PCN – Product Change Notification

Document No	PCN-B-080602	Revision	1.0		
-------------	--------------	----------	-----	--	--

ECN Topic: New 8.4 inches Wide Temperature Rear Mount Dimension

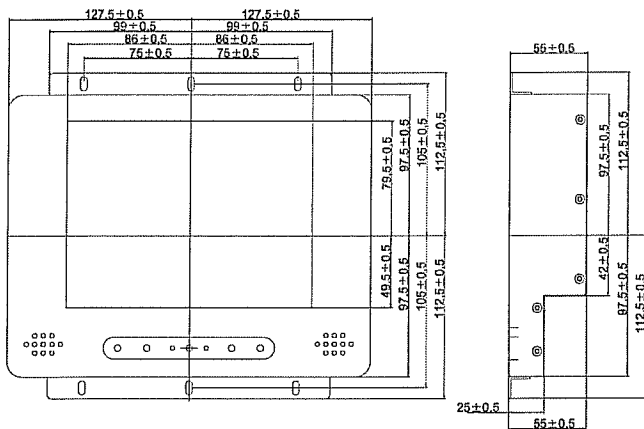
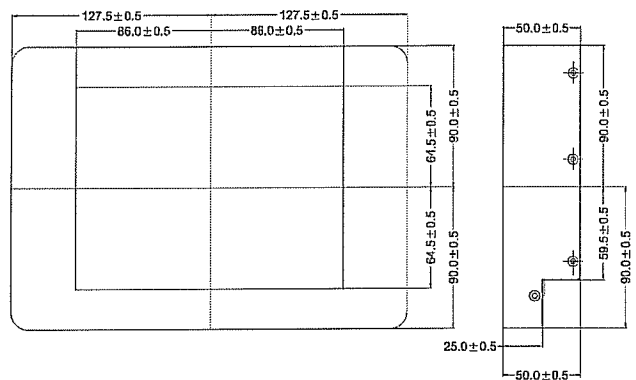
We will release new dimension for 8.4" Wide Temperature Rear Mount LCD. The dimension of mechanical will change from 225 x 195 x 55 mm to 255 x 180 x 50 mm and change the position of OSD to back side.
